ENGINEERINGUPDATE

NO: SW - 114 PRODUCT: A6E-N – Dip Switches

DATE: January 2017 TYPE: MODIFICATION – Structure and Shape Change

A6E-N DIP Switches: Upgraded to Semi-Sealed Construction

A6E-N Details of the Changes:

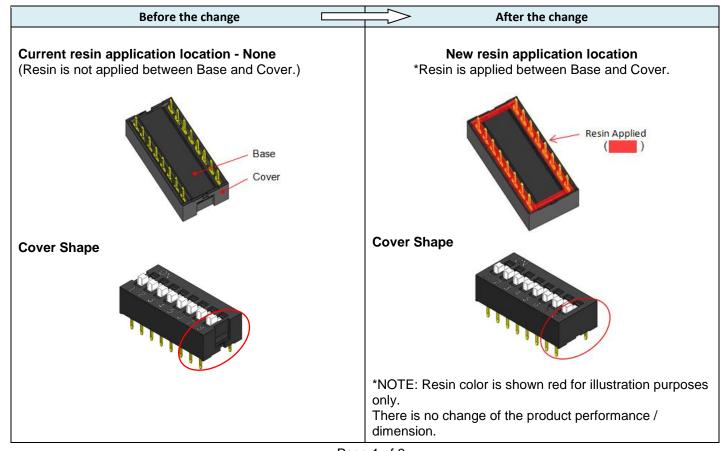
In an effort to enhance product reliability of Omron's line of Dip Switches, OMRON will modify the structure and cover of the listed A6E-N models effective as our production beginning July 2017. The newly modified A6E-N Dip Switches will now be semi-sealed to prevent contact failures caused by flux ingress. PCB layout and overall dimensions will remain unchanged. Please carefully read through this notification and note the differences; the models to be affected include, but are not limited to the models listed below; should you have any additional questions, however, please communicate with the Switch Product Specialist.
